EL PASO WATER – PUBLIC SERVICE BOARD

Bid No. 01-23 – Northeast Dyer/Railroad Lift Station

ADDENDUM 1

RESPONSES TO BIDDERS

**SHEET NO.**  
C-106 of 9

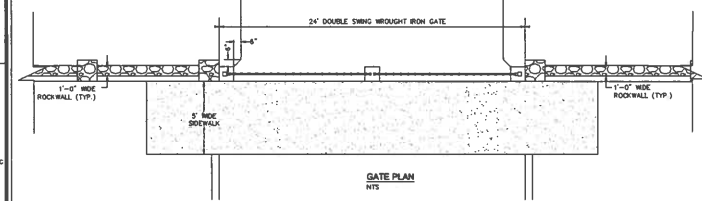
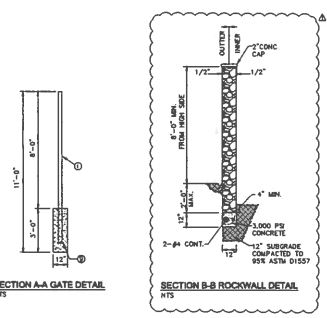
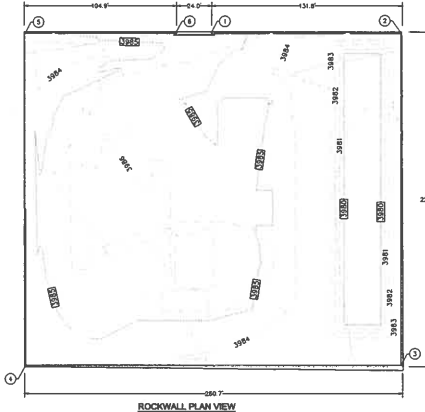
Item No.	Page or Drawing No.	Location and Description of Change
1.03	C-106	CIVIL DETAILS. <b>REPLACE</b> in its entirety with attached new Sheet C-106.
1.04	C-406	PHASE 1 WET WELL ENTRANCE AND VALVE VAULT EQUIPMENT ELEVATION. <b>REPLACE</b> in its entirety with attached new Sheet C-406.

<p>Q5: "Civil details page C-106 the table for Rockwall Spot Elevation indicates Top of wall Elevation, our question is if that Top of Wall Elevation is including the pillars/columns or just the rock wall itself?"</p> <p>A5: Refer to Revised Section B-B on Revised Sheet C-106, attached. Refer to revised "Rockwall Spot Elevation Table," on Revised Sheet C-106. The wall must be a minimum 8'-0" from the exterior finished ground level to the bottom of the cap stone. This height corresponds to the final height of the wrought iron sections. The height associated with the top of cap stone is in addition to the required 8'-0" wall height. The height of unbalanced backfill (retaining height) against either side of wall shall not exceed 2'-0".</p>
		<p>Q6: "Please provide the geotechnical report"</p> <p>A6: The Geotechnical report has been posted by EPWater and is available for download and review.</p>

SHEET C-406 OF 56

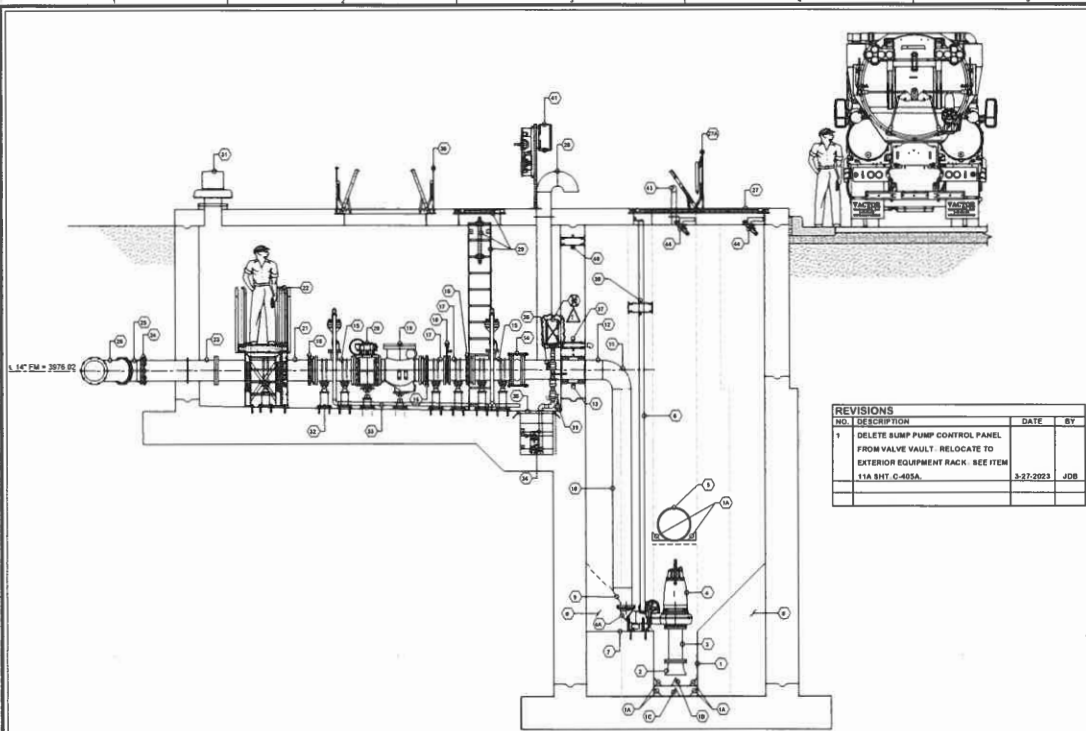
Item No.	Page or Drawing No.	Clarification provided by the Engineer
1.06		<ol style="list-style-type: none"><li data-bbox="573 449 1351 573">1. All ductile iron pipe shall have a minimum working pressure rating of 350 psi. PC350 ductile iron pipe shall be used for buried installations and Thickness Class 53 pipe shall be used where flanged connections are required.</li><li data-bbox="573 611 1351 735">2. Specification 44 31 19.02 states that the I-BOx-700 is to be used for the future Phase 2 wet well. This statement is incorrect. Disregard references to Phase 2 in 44 31 19.02. The I-BOx-7000 shall be used for Phase 1 only.</li><li data-bbox="573 772 1351 919">3. Sheet C-406 of the plans As-Bid shows the valve vault sump pump control panel located in the valve vault. The sump pump control panel has been relocated to the exterior equipment rack as shown by Item 11A on Sheet C-405A. See Revised Sheet C-406, attached.</li></ol>

NO.	DESCRIPTION	DATE	BY
1	DELETE SUMP PUMP CONTROL PANEL FROM VALVE VAULT. RELOCATE TO EXTERIOR EQUIPMENT RACK. SEE ITEM #11A BHT-C-405A.	3-27-2023	JDB
